ADDENDUM NO. 01 June 24, 2025

To Drawings and Specifications dated June 10, 2025.

PKG 3A – GPHS New Fieldhouse

Prepared by:	PBK
	11 Greenway Plaza, 22 nd Floor
	Houston, TX 77046-1104
	PBK Project No: 240539

Plot Stamp: 6/24/2025 10:58:13 AM **2ND FLOOR PLUMBING PLAN** SCALE: 1/8" = 1'-0"

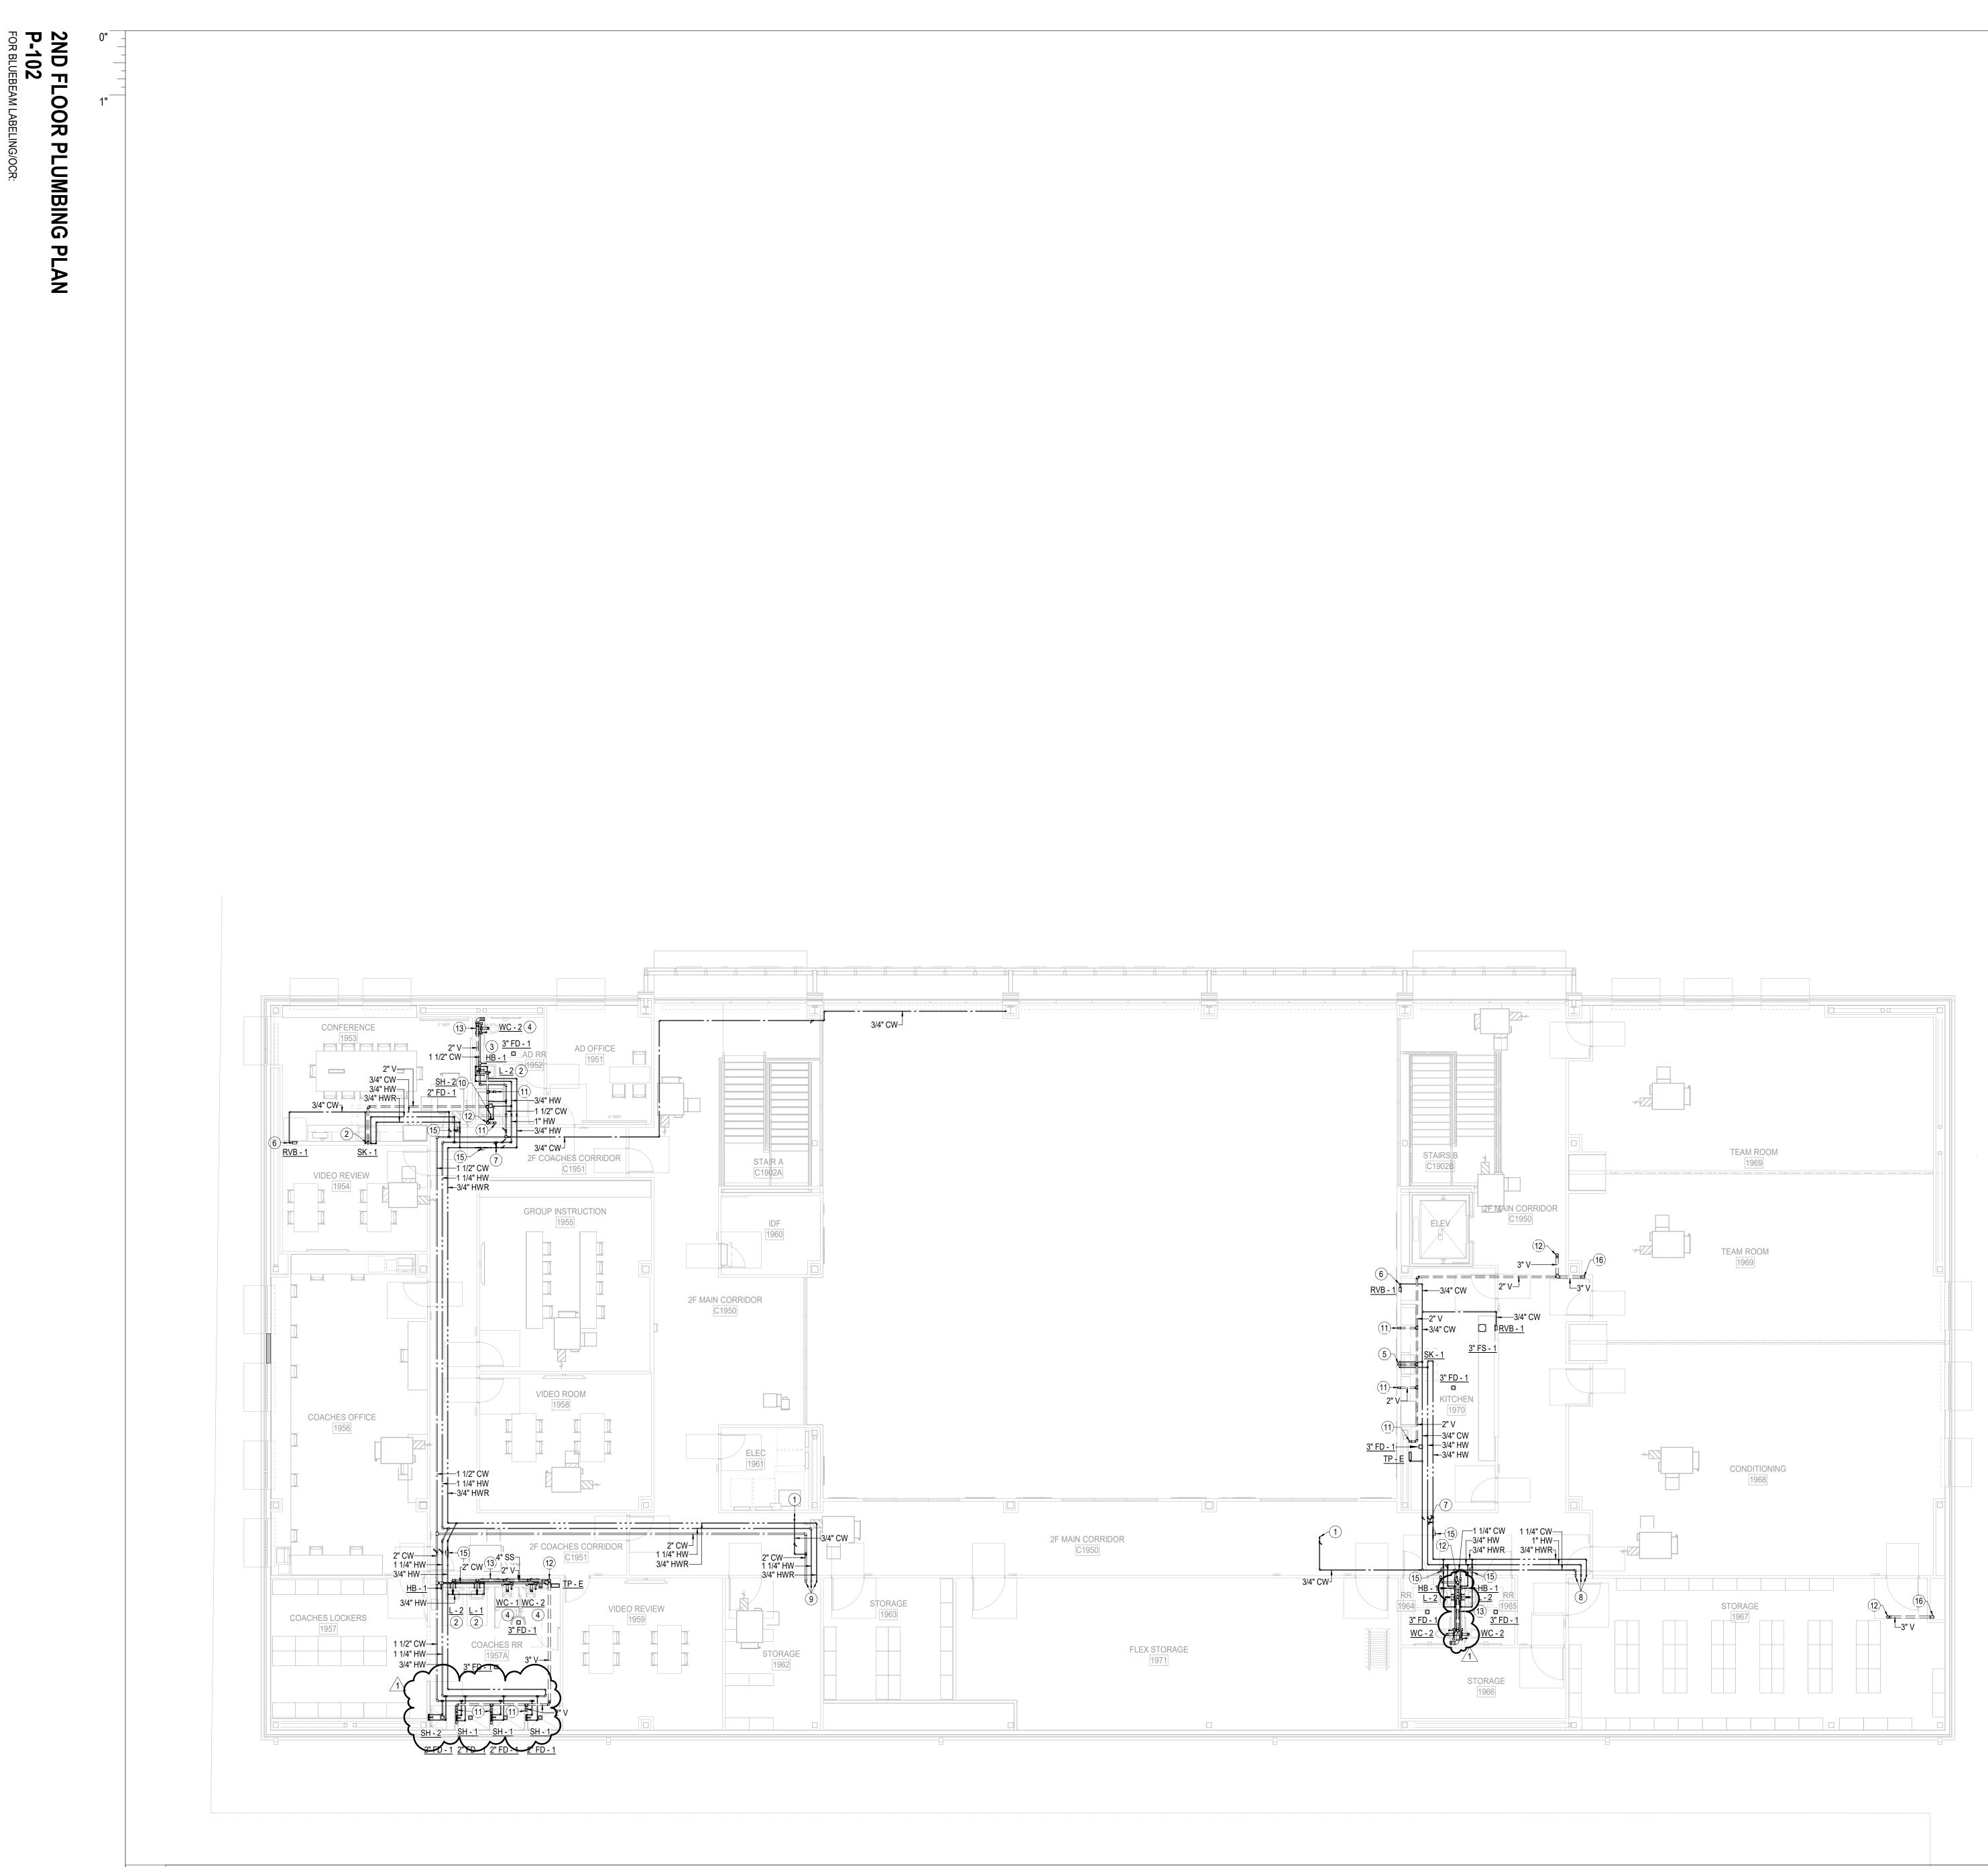
Item No. 02 P102 – 2ND FLOOR PLUMBING PLAN
